PLANNING & ZONING AGENDA ITEM #7

SUBJECT: Approval of a Rezoning Request for a change in zoning from R-1 [Single Family Residential District] to R-4 [Row Dwelling and Townhome District] and to amend the Planned Development for Glynn Village

RE: Glynn Village Rezoning: R-1 Single Family Residential District to R-4 Row Dwelling and Townhome District and an amendment to the Planned Development (PD-1) for Glynn Village

RE: Glynn Village - P.U.D. Amendment

AMENDMENT MAP [Rezoning Ownership Map – Booth Ave]

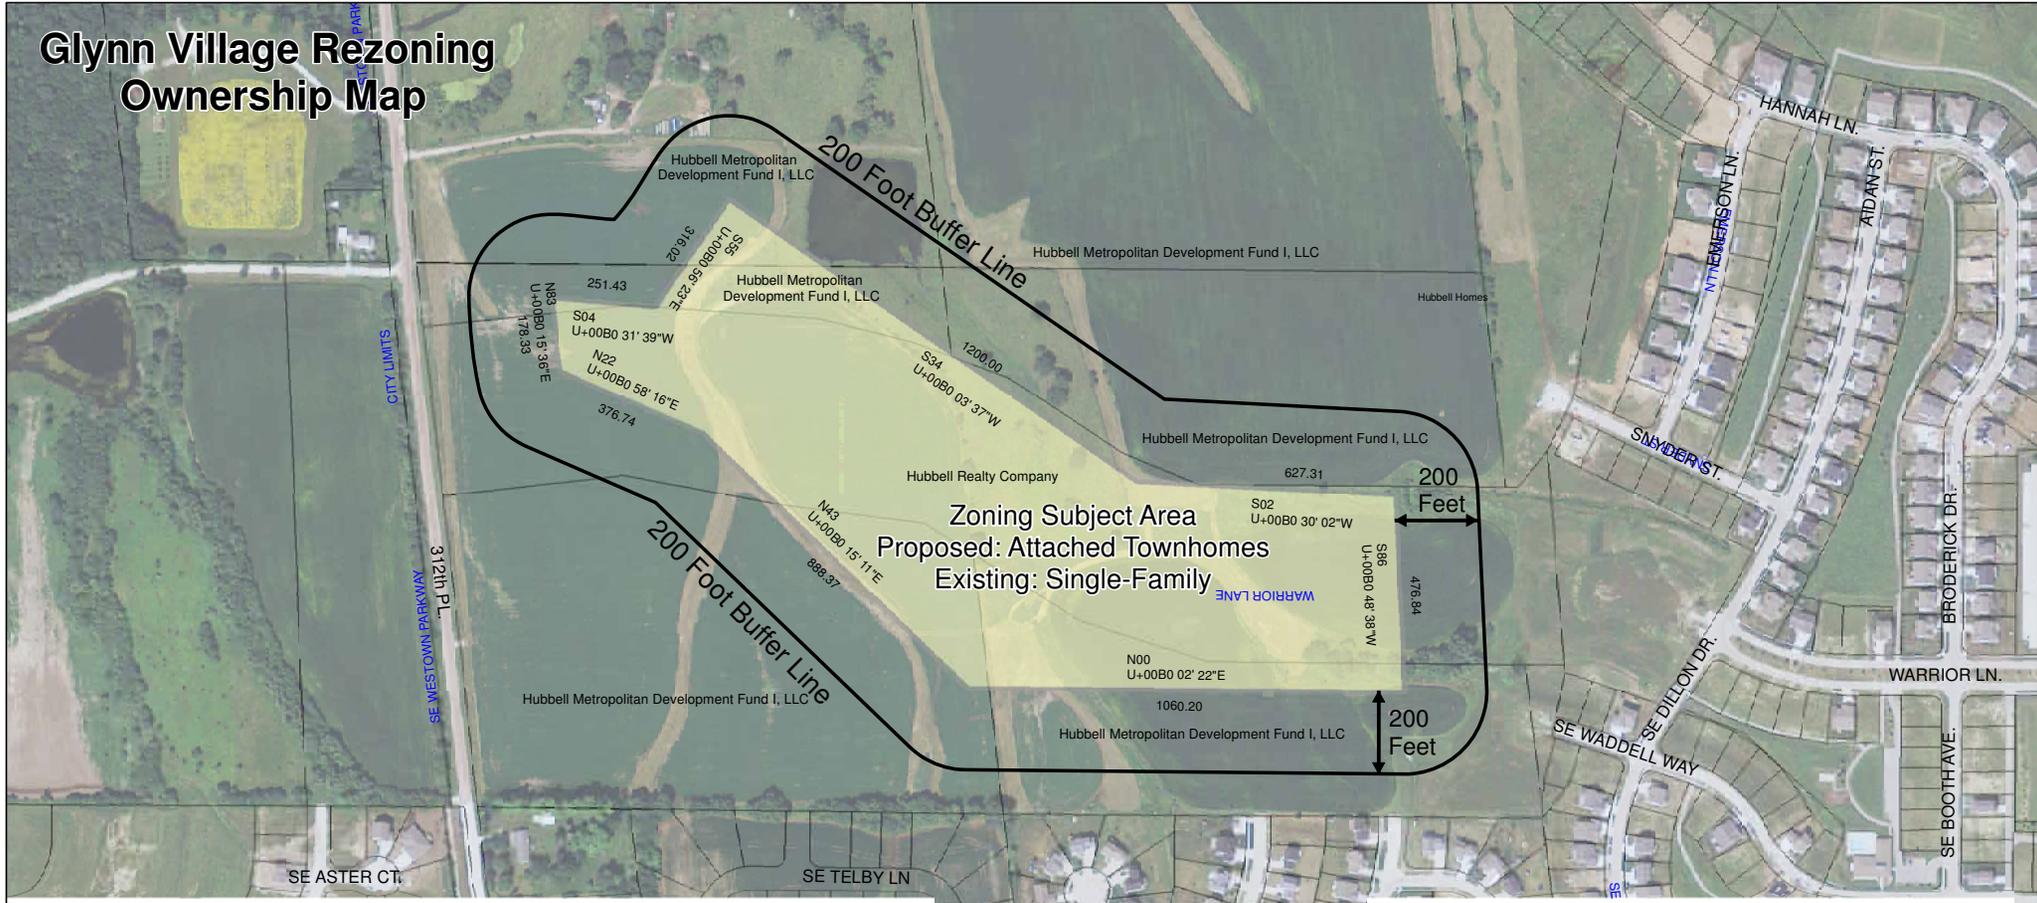
6. The rezoning map should identify the proposed change from PD R-1 to PD R-4.
7. The rezoning map should reflect various parcels within the 200 foot buffer (excluding right of ways) with the individual ownership information corresponding within the rezoning table.
8. A vicinity sketch should be provided on the rezoning map which identifies the proposed rezoning location in relationship to the overall Glynn Village Development.
9. The proposed areas to be rezoned from R-1 to R-4 underlying districts, should show bearings and distances on the plan corresponding to the legal description.

AMENDMENT MAP [Rezoning Ownership Map – Warrior Lane]

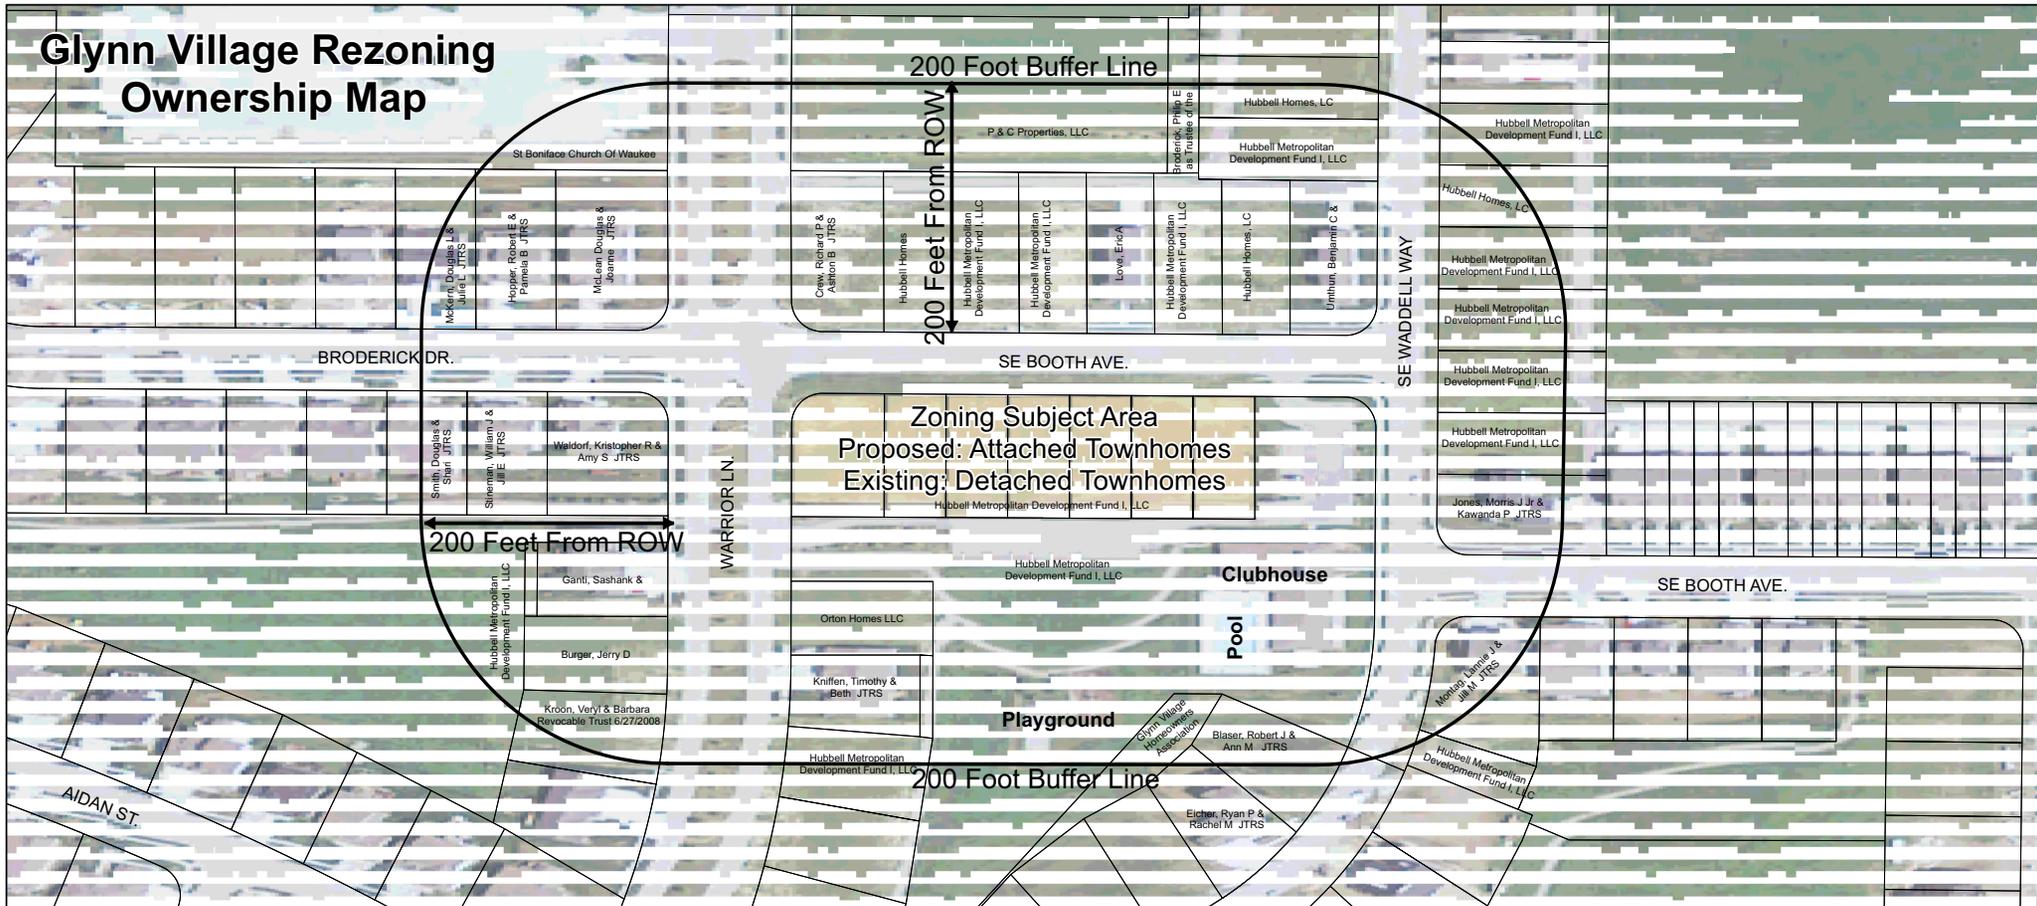
2. The rezoning map should identify the proposed change from PD R-1 to PD R-4.
3. The rezoning map should reflect various parcels within the 200 foot buffer (excluding right of ways) with the individual ownership information corresponding within the rezoning table.
4. A vicinity sketch should be provided on the rezoning map which identifies the proposed rezoning location in relationship to the overall Glynn Village Development.
5. The proposed areas to be rezoned from R-1 to R-4 underlying districts, should show bearings and distances on the plan corresponding to the legal description.
